**TOPOGRAPHIC SURVEY
SEASPECT SHORT PLAT
JOHN KAHAN**

NO.	DESCRIPTION	DATE
3	PERMIT REVISION	04.19.22
4	PERMIT REVISION 2	06.10.22
5	PERMIT REVISION 3	08.30.22

CLARKSON RESIDENCE
8163 W MERCER WAY
 City of Mercer Island, Washington

1 PROPOSED ROOF PLAN
1/4" = 1'-0"

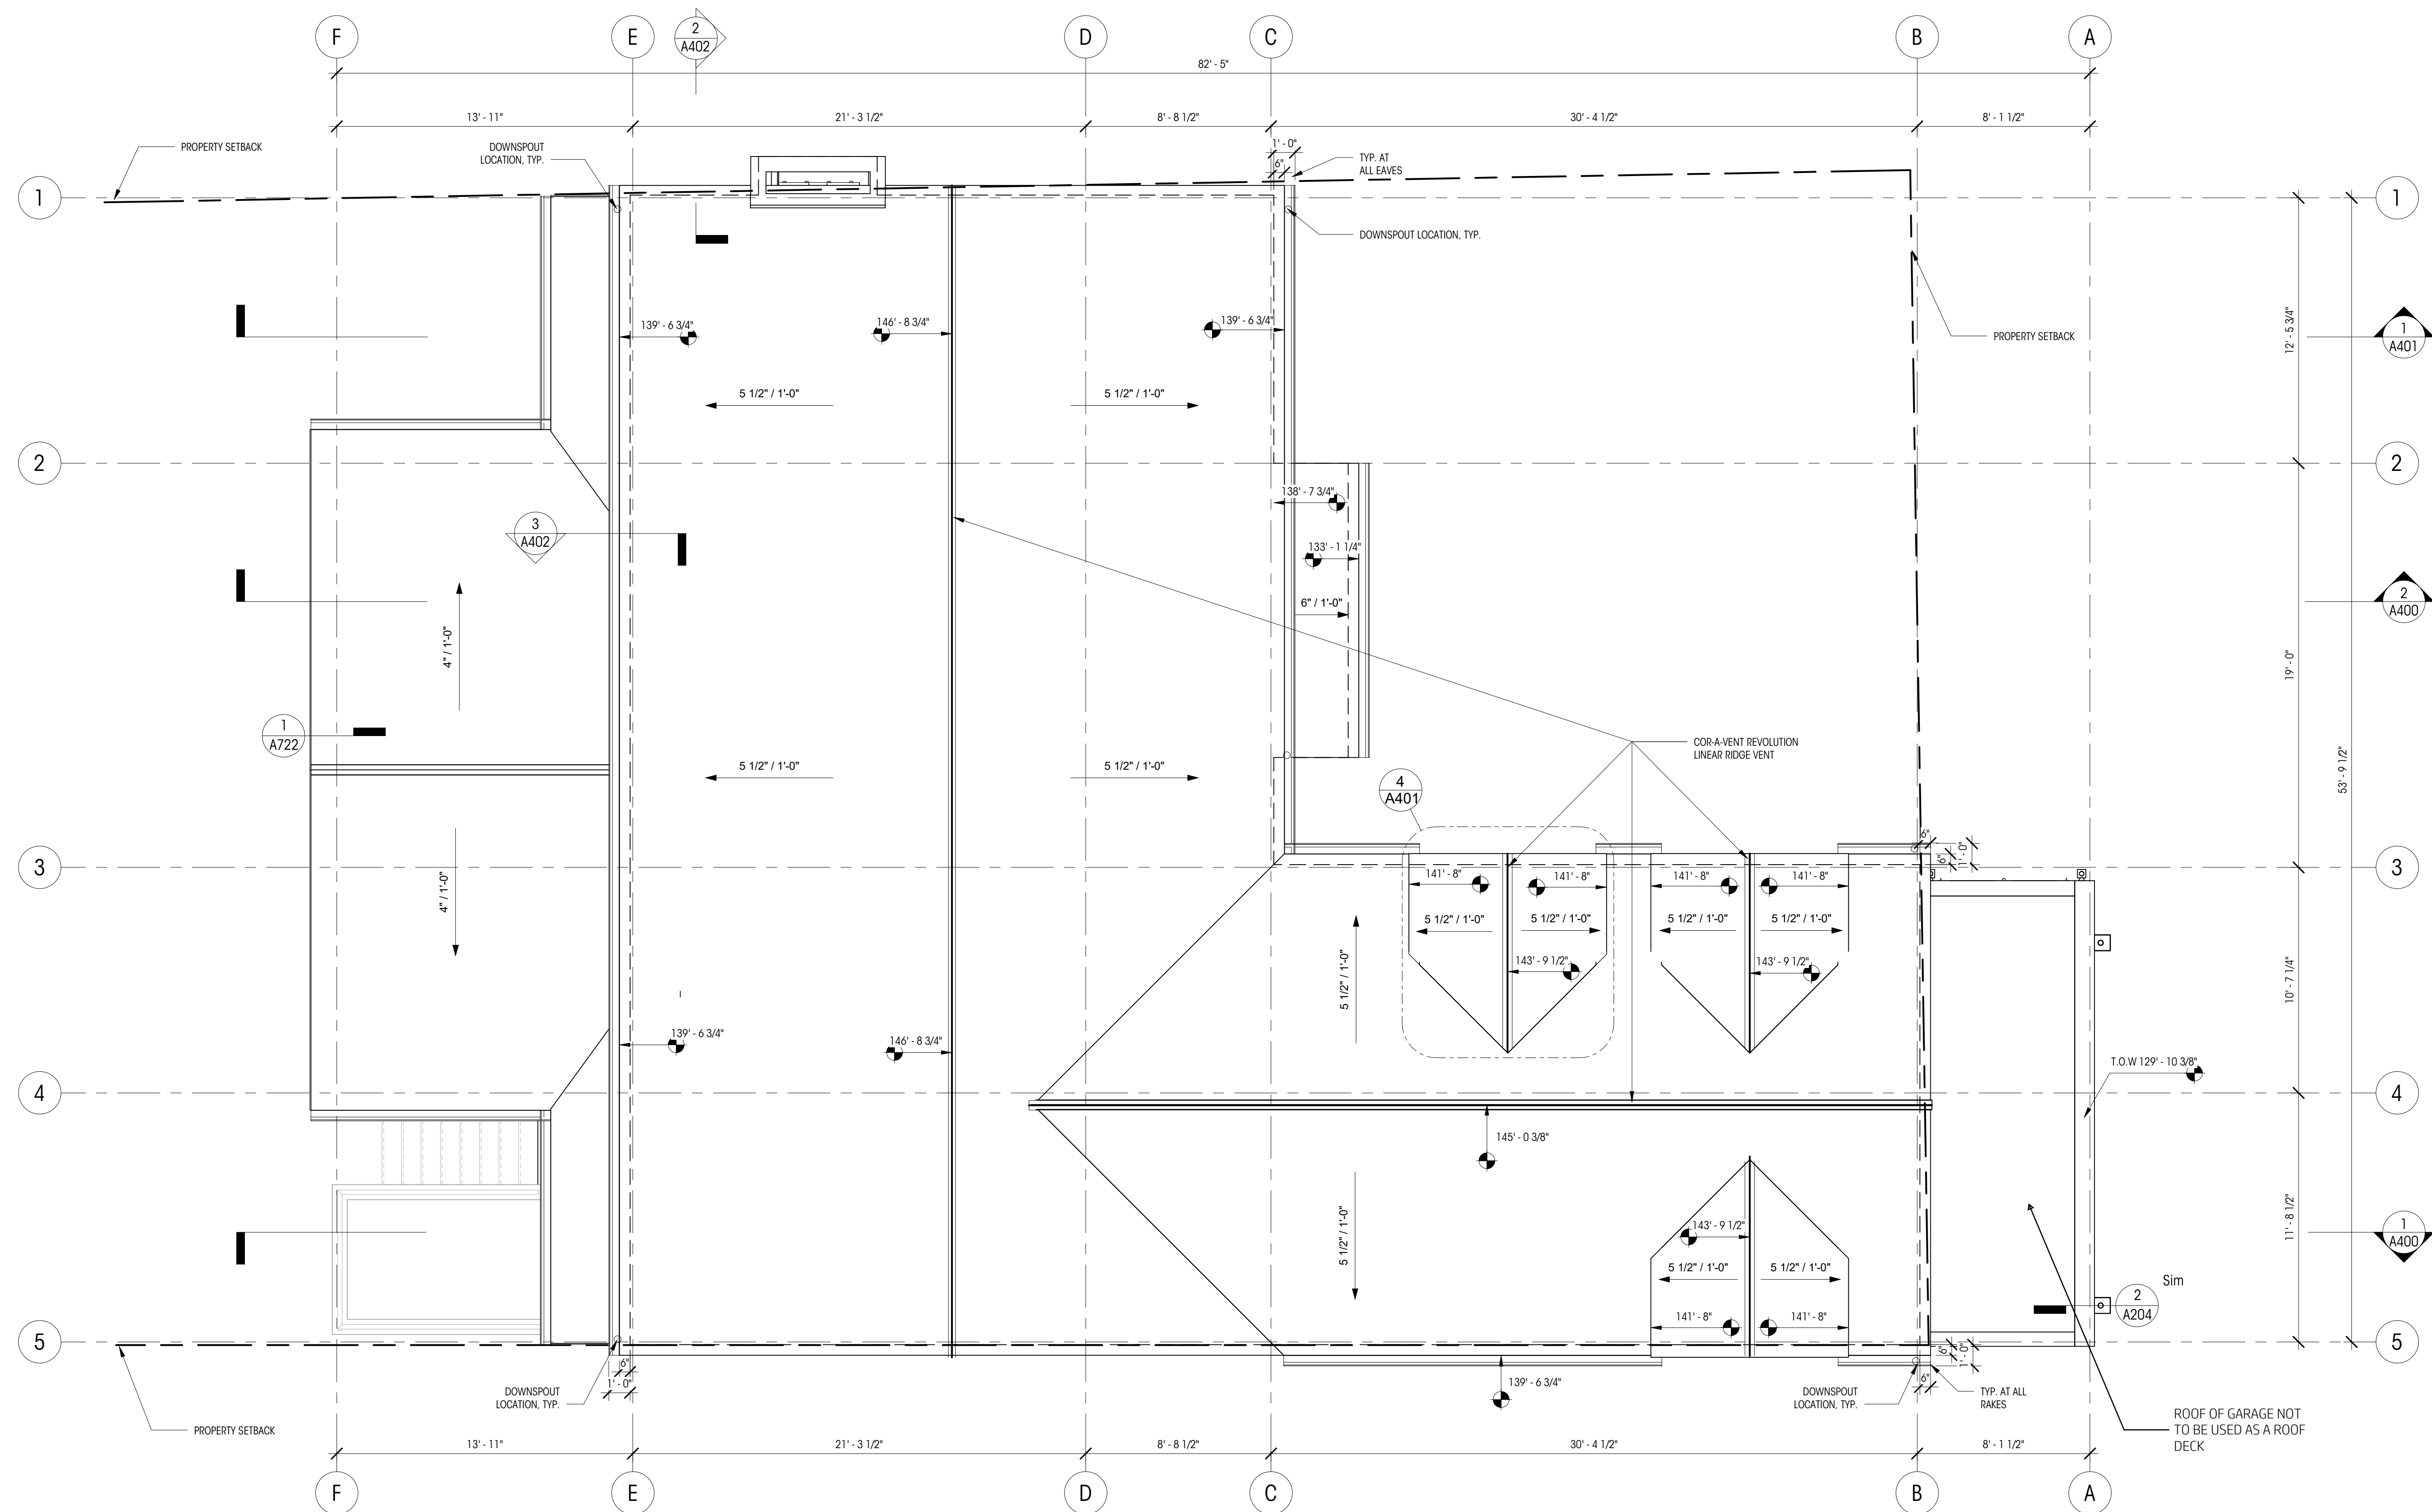
- CHANGE ROOF OF AND EXTEND WESTERN PATIO TO THE WEST AND SOUTH
- ADDED DORMERS AT UPPER LEVEL BONUS ROOM
- ADDED DECK AT ROOF OF THE EXTENDED GARAGE AREA.
- ADDED DETAIL FOR EXTENDED DECK DRAINAGE
- UPDATED ROOF VENTING CALCS AS A RESULT OF DORMER ADDITION
- REDUCED ROOF PITCH FROM 6:12 TO 5.5:12.

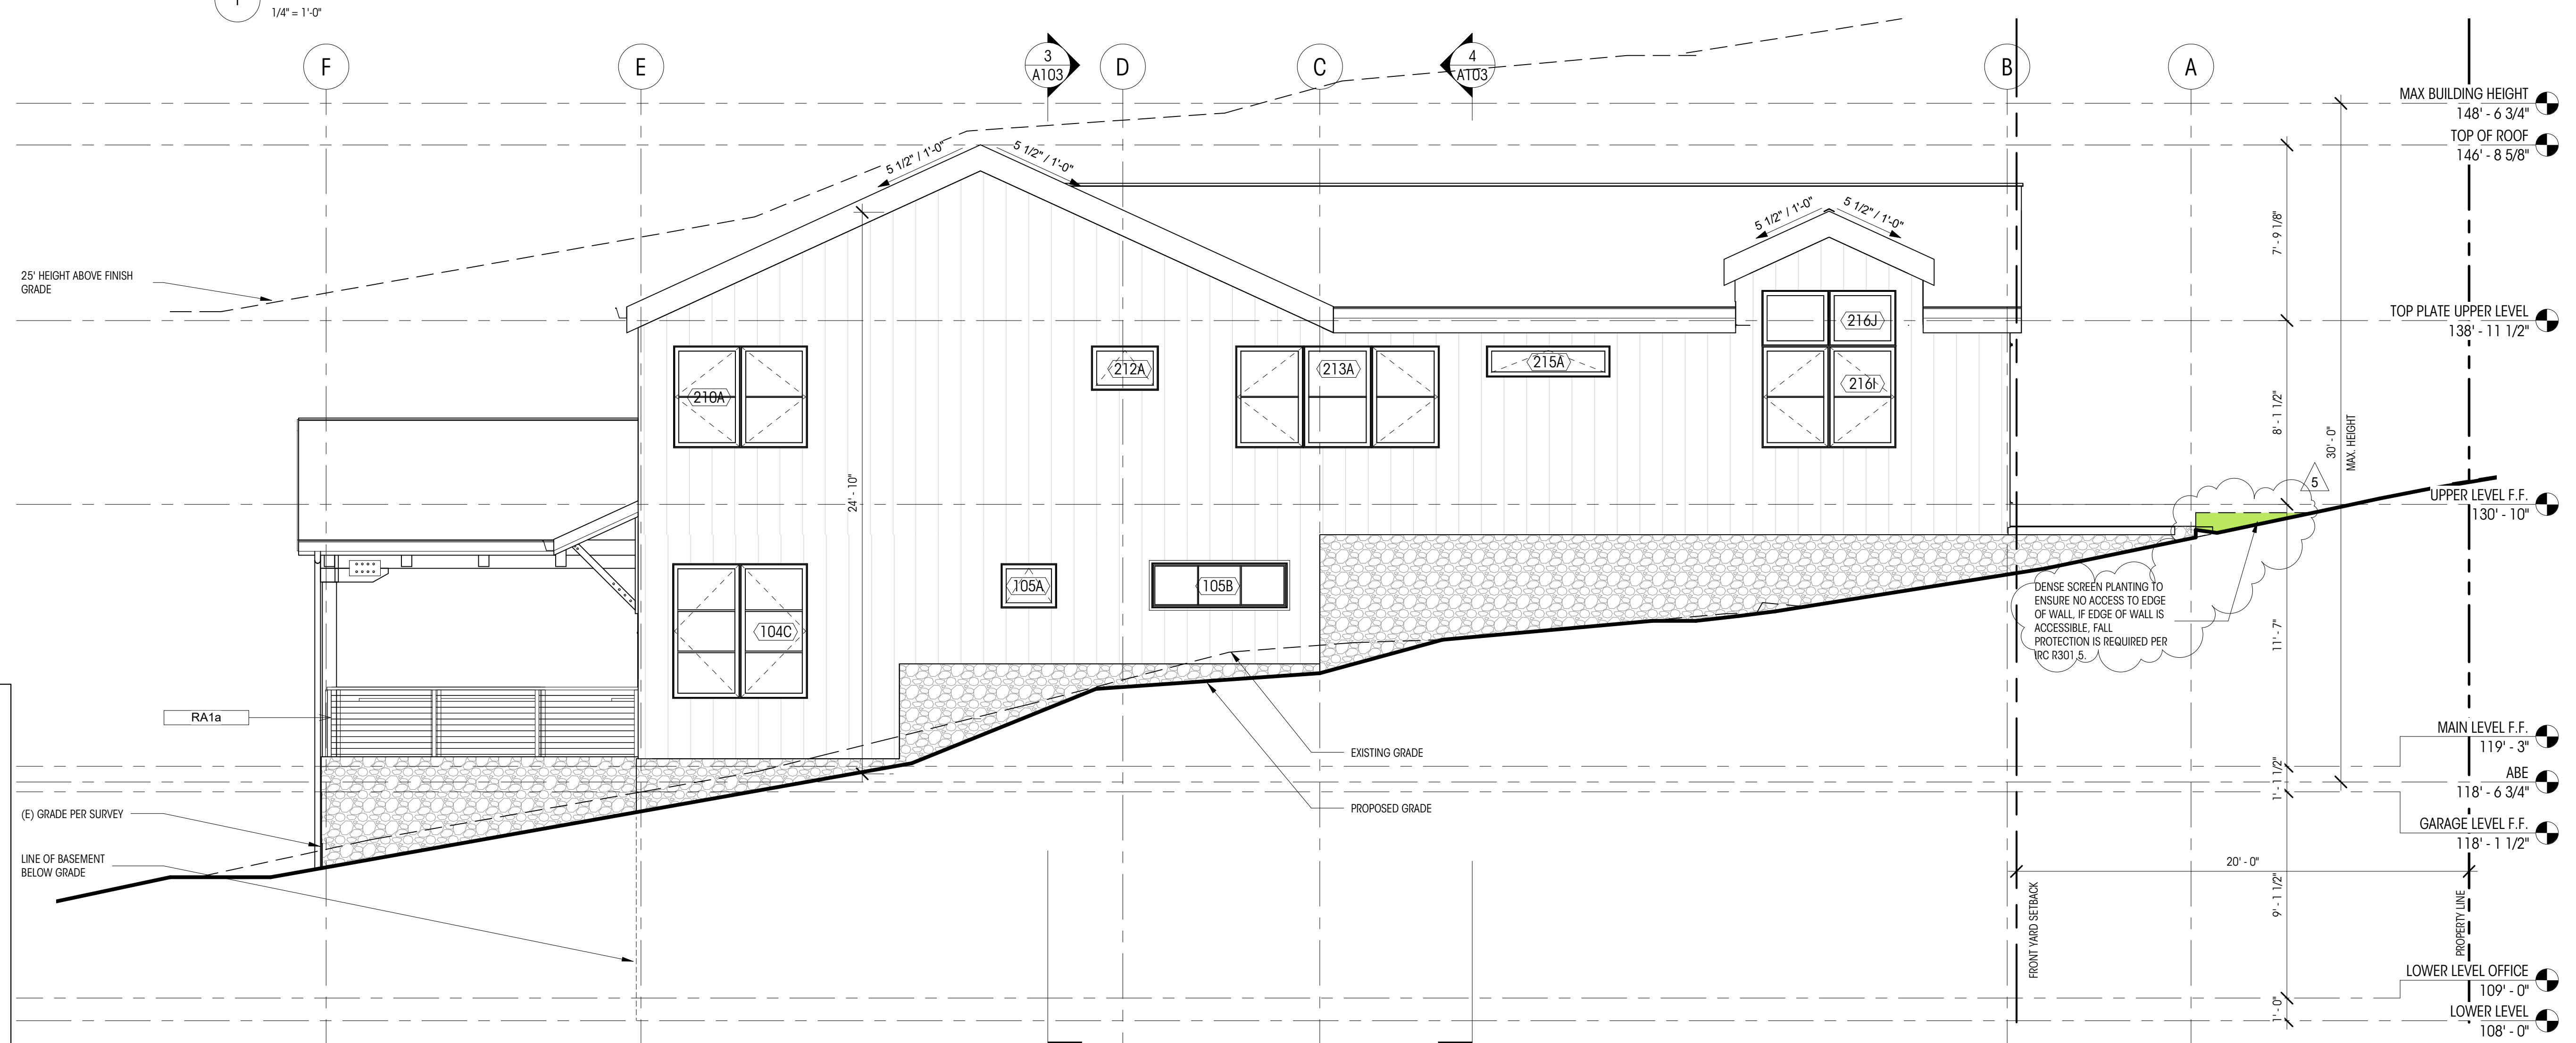
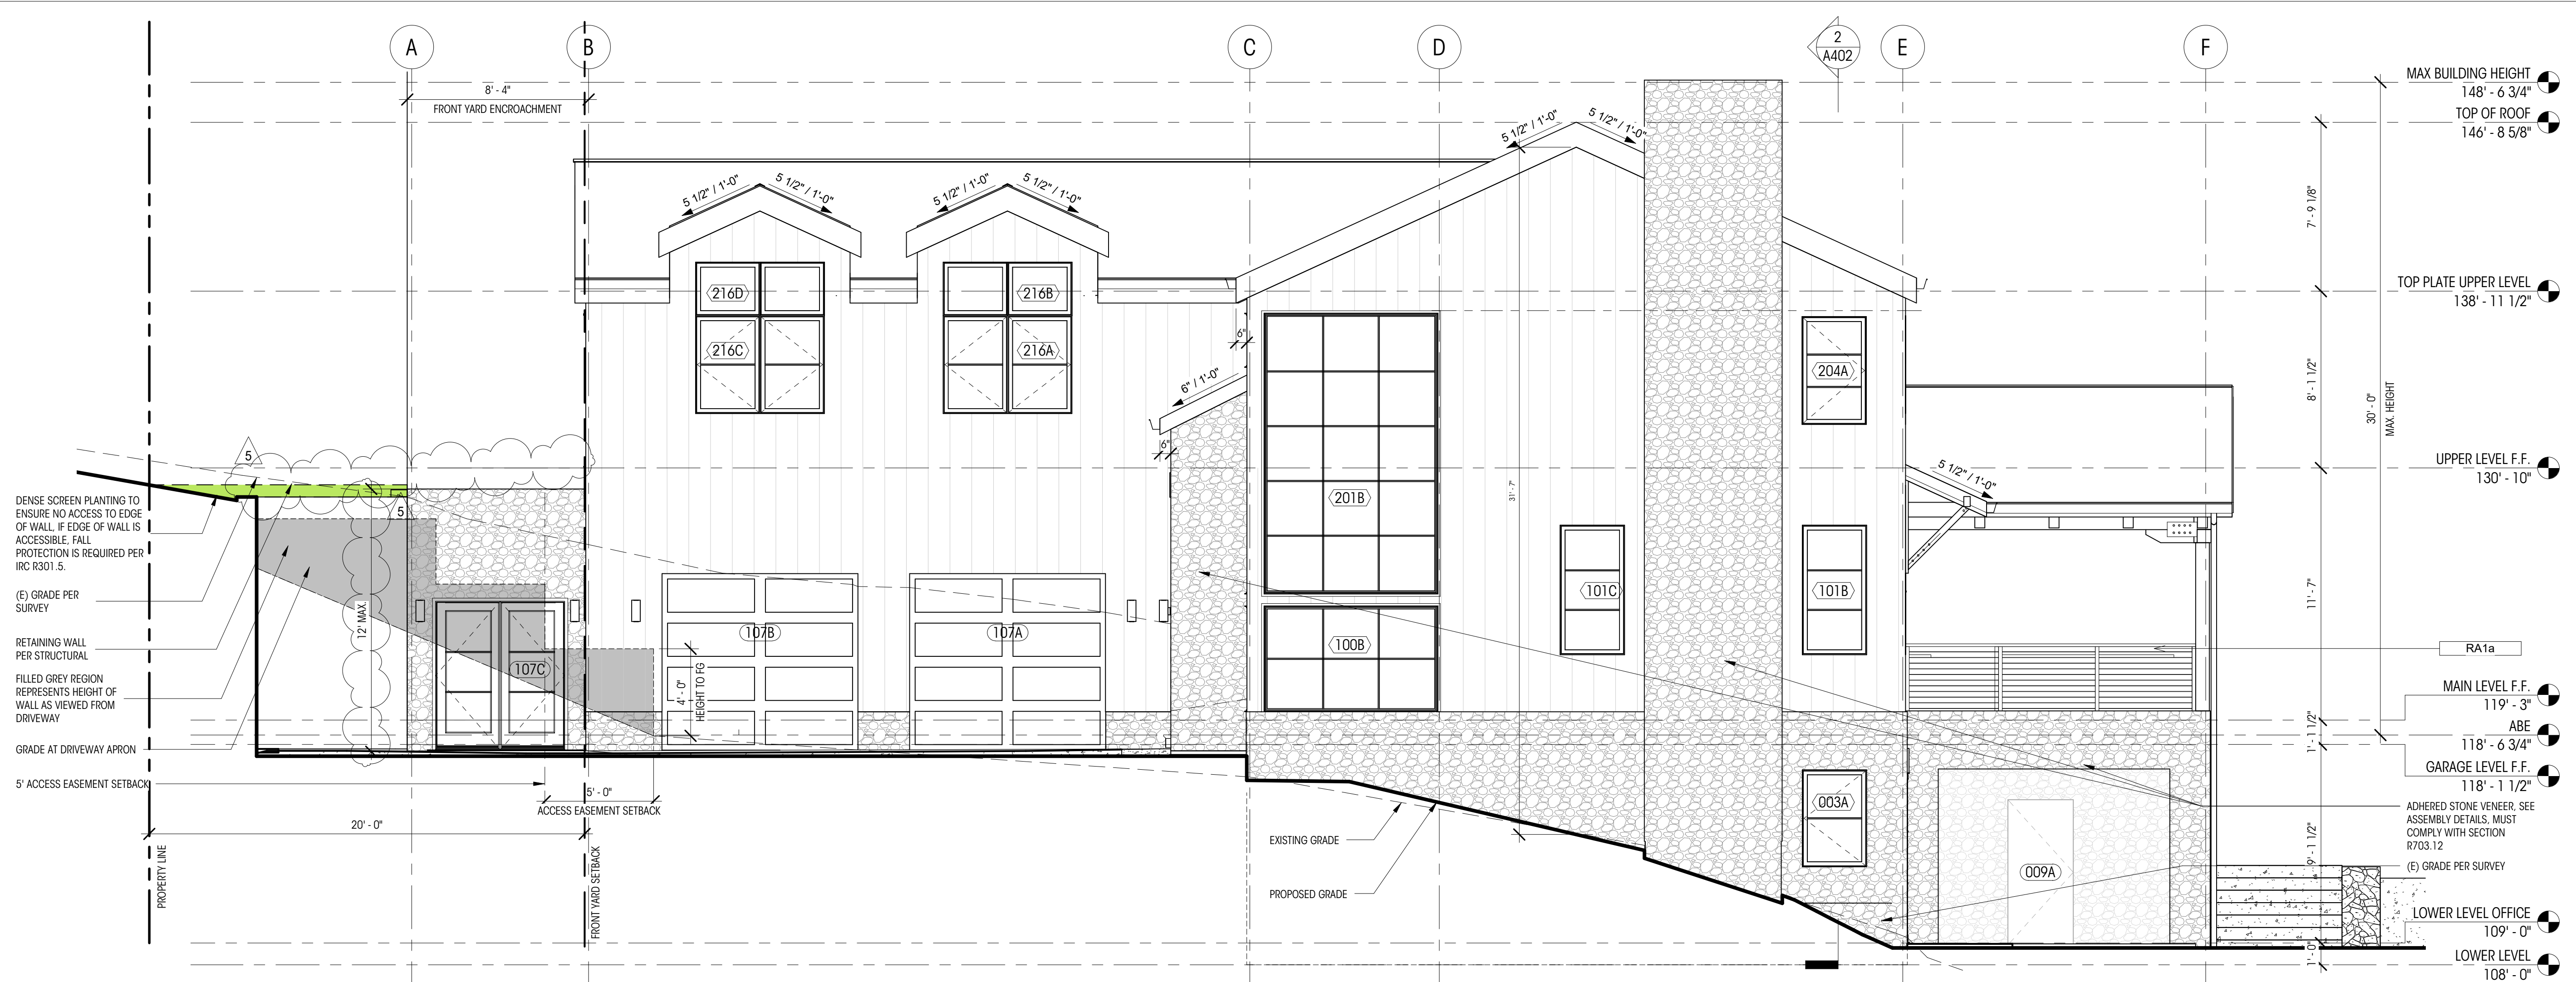
- CHANGE ROOF OF AND EXTEND WESTERN PATIO TO THE WEST AND SOUTH
- ADDED DORMERS AT UPPER LEVEL BONUS ROOM
- EXTEND GARAGE EAST INTO FRONT YARD SETBACK AS ALLOWED BY CODE 19.02.040.D
- WINDOW SIZE & LOCATION CHANGES
- LEVEL CHANGES:
 - a. DRIVEWAY & GARAGE LEVEL DROP BY 15"
 - b. BASEMENT LEVEL DROP BY 12"
 - c. UPPER LEVEL DROP BY 2"
 - d. FRAMED FLOOR 12" ABOVE BASEMENT FLOOR.
 - e. CHANGE TO ABE AS A RESULT OF EXTENDED GARAGE AND EXTENDED COVERED DECK
 - f. CHANGE TO MAX HEIGHT AS A RESULT OF THE ADJUSTMENT TO THE ABE.
 - g. TOP PLATE LEVEL ADJUSTED UP BASED ON ROOF FRAMING
 - h. ROOF OF ROOF HAS LOWERED AS A RESULT OF REDUCED ROOF PITCH
- SITE WALL MATERIAL CHANGE
- UPDATED STEPPING FOUNDATION WALL PROFILE TO MATCH STRUCTURAL
